Project Name & Address: 101 N Hamilton Street, Draper Brothers Block

Application Type(s): Certificate of Appropriateness for exterior alterations to a Designated Madison Landmark

Prepared By: Heather Bailey, Preservation Planner, Planning Division

Date Prepared: July 20, 2021

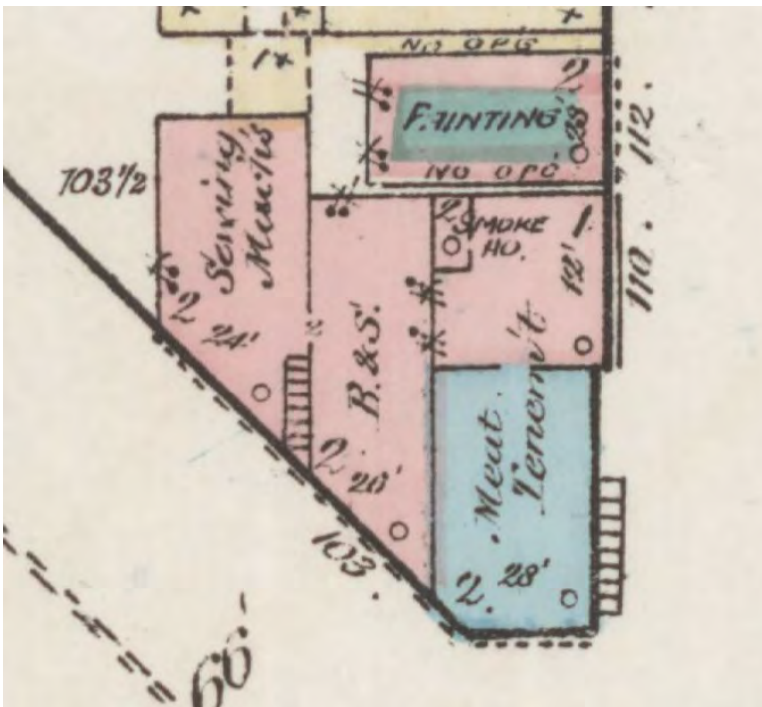
The applicant is requesting a Certificate of Appropriateness for exterior alterations, including repainting the already painted masonry exterior, creating new window openings on the Mifflin St façade, filling a window opening with brick, replacing nonhistoric 2nd floor windows on the front façade, repairing a remaining historic window on the 2nd floor, replacing nonhistoric side doors, installing a limestone base along the E Mifflin Street façade, removing an existing patio at the front corner of the building and replacing it with a ground-level planter and new entrance stairs, and adding a panel signage board.

Both of the buildings involved in this proposal have undergone changes over time. The current proposal should be addressed as three separate scopes of work: replacement of the nonhistoric deck on the front of the structure, alterations for the side of the stone building, and alterations for the front of the brick building. The removal of the nonhistoric deck on the front and construction of new entrance stairs would essentially return this area to its historic appearance. The proposal to install a short planter has the potential to introduce a tripping hazard for pedestrians and staff has recommended increasing the wall height for the planter.

For the side of the stone building the proposal is to introduce additional window openings, repair a remaining historic window, replace a nonhistoric entry door, introduce a new sign band across the entire length of the façade and continue the decorative band from the front façade. Staff has recommended that the applicant continue the window pattern from the front façade with single-width windows on the upper floor and the proposed double width windows on the first floor. Staff has also recommend not continuing the decorative belt band from the front façade across to this façade. The front façade is decorative and the side of the building does not have ornamentation. A simple flat board to continue the line or no belt band would be more appropriate. For a new sign panel, staff has recommended that be limited to just above the entrance on that façade and not span the length of the façade.

For the brick building, while there have been significant alterations over time, we have the evidence that there were single width windows on both the first and second floors. There are no historic photos older than the 1947 photo, so we must rely upon the forensic evidence on the building itself. Rather than introducing a new double-width window at the street level, staff has recommended a window that is of the same proportions as the existing. Staff agrees with the proposal to brick in the first floor window that currently does not go to a functional interior space, but this window opening can remain on the façade as evidence of the past location of the window. There is currently a parged area that was historically used as a large signage area. The current proposal is to extend that parging across the rest of the already painted brick as removal of the existing parging is likely to be highly damaging to the historic brick underneath. As the existing brick would remain as evidence of the historic building material on the upper floor, this approach would return the façade to more of a storefront

Staff believes the standards for granting a Certificate of Appropriateness could be met and recommends that the Landmarks Commission provide detailed feedback to the applicant and refer the item to a future meeting so that the applicant can update the proposal to meet the Secretary of the Interior's Standards.
